Issue detail

Created on	Nov 2, 2026, 11:36 AM PST
Created by	**Emily Zhu** (F26-CEE120A_220A)
Total items	8
Sorted by	ID (Ascending)
Filtered by	Created on (Oct 26, 2026 - Nov 2, 2026)

#1: Concrete-Rectangular-Column [1256409] and Compound Ceiling [530186]

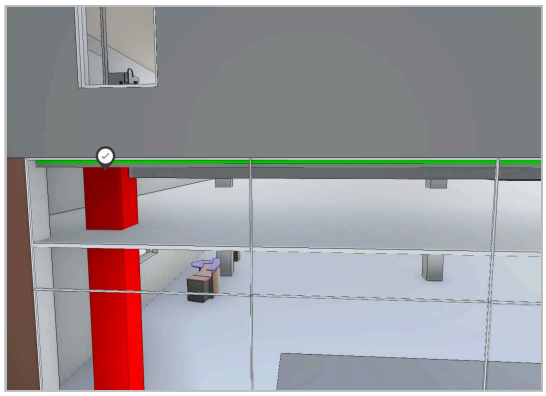
Status	Open
Type	CL Coordination > Clash
ID	#1
Description	1 clash between Concrete-Rectangular-Column [1256409] in Module 6_Structural Model.rvt - 3D - Structural Coordination and Module 6_Arch.rvt - 3D - Architectural Coordination Clash between ceiling and concrete columns - potential incorrect ceiling height specified during creation
Assigned to	—
Created by	Emily Zhu (F26-CEE120A_220A)
Created on	Nov 2, 2026
Location	—
Location details	—
Due date	—
Start date	—
Placement	Module 6_Arch.rvt
Root cause	—

#3: Concrete-Rectangular-Column [1256411] and Table-Coffee Rectangular [560090]

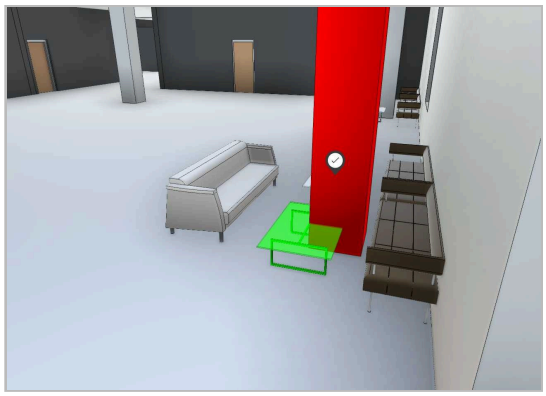
Status	Open
Type	CL Coordination > Clash
ID	#3
Description	1 clash between Concrete-Rectangular-Column [1256411] in Module 6_Structural Model.rvt - 3D - Structural Coordination and Module 6_Arch.rvt - 3D - Architectural Coordination Clash with concrete column and arranged furniture - move sofa and chairs to accommodate for structural column
Assigned to	Emily Zhu (F26-CEE120A_220A)
Created by	Emily Zhu (F26-CEE120A_220A)
Created on	Nov 2, 2026
Location	—
Location details	—
Due date	—
Start date	—
Placement	Module 6_Structural Model.rvt
Root cause	—

#4: Concrete-Rectangular-Column [1256412] and Table-Coffee Rectangular [560523]

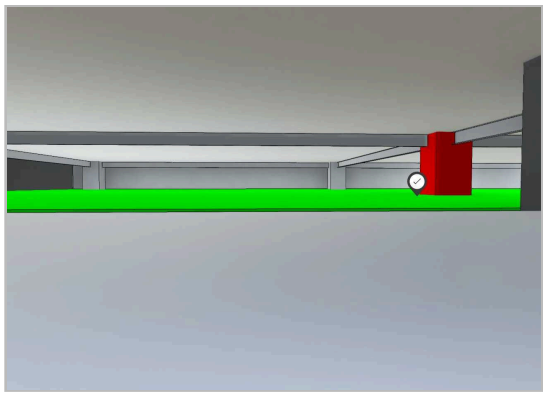
Status	Open
Type	CL Coordination > Clash
ID	#4
Description	1 clash between Concrete-Rectangular-Column [1256412] in Module 6_Structural Model.rvt - 3D - Structural Coordination and Module 6_Arch.rvt - 3D - Architectural Coordination Clash with concrete column and arranged furniture - move sofa and chairs to accommodate for structural column
Assigned to	Emily Zhu (F26-CEE120A_220A)
Created by	Emily Zhu (F26-CEE120A_220A)
Created on	Nov 2, 2026
Location	—
Location details	—
Due date	—
Start date	—
Placement	Module 6_Structural Model.rvt
Root cause	—

#6: Concrete-Rectangular Beam [1257508] and Otis_Elevator_-_Single_Gen2_3500lb_Capacity_6666 [516845]

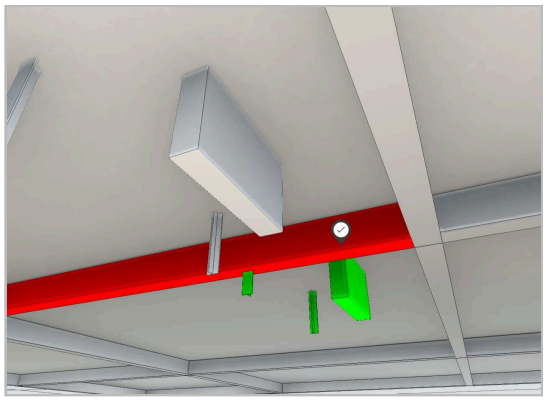
Status	Open
Type	CL Coordination > Clash
ID	#6
Description	1 clash between Concrete-Rectangular Beam [1257508] in Module 6_Structural Model.rvt - 3D - Structural Coordination and Module 6_Arch.rvt - 3D - Architectural Coordination Concrete beam clash with bottom of elevators, change offset of elevators or shift slightly to resolve
Assigned to	Emily Zhu (F26-CEE120A_220A)
Created by	Emily Zhu (F26-CEE120A_220A)
Created on	Nov 2, 2026
Location	—
Location details	—
Due date	—
Start date	—
Placement	Module 6_Structural Model.rvt
Root cause	—

#7: Concrete-Rectangular-Column [1256416] and 2 other objects.

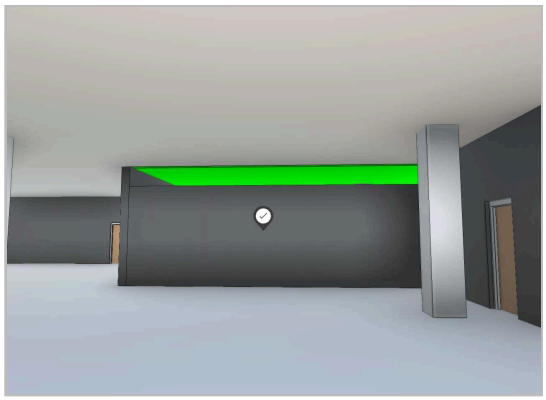
Status	Open
Type	CL Coordination > Clash
ID	#7
Description	2 clashes between Concrete-Rectangular-Column [1256416] in Module 6_Structural Model.rvt - 3D - Structural Coordination and Module 6_Arch.rvt - 3D - Architectural Coordination wall doesn't fully extend up to ceiling
Assigned to	Emily Zhu (F26-CEE120A_220A)
Created by	Emily Zhu (F26-CEE120A_220A)
Created on	Nov 2, 2026
Location	—
Location details	—
Due date	—
Start date	—
Placement	Module 6_Arch.rvt
Root cause	—

#8: Concrete-Rectangular-Column [1256424] and 2 other objects.

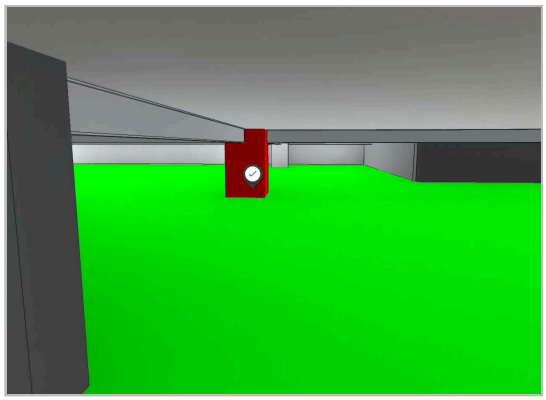
Status	Open
Type	CL Coordination > Clash
ID	#8
Description	2 clashes between Concrete-Rectangular-Column [1256424] in Module 6_Structural Model.rvt - 3D - Structural Coordination and Module 6_Arch.rvt - 3D - Architectural Coordination column extends above ceiling - check ceiling offset height and column height
Assigned to	—
Created by	Emily Zhu (F26-CEE120A_220A)
Created on	Nov 2, 2026
Location	—
Location details	—
Due date	—
Start date	—
Placement	Module 6_Structural Model.rvt
Root cause	—
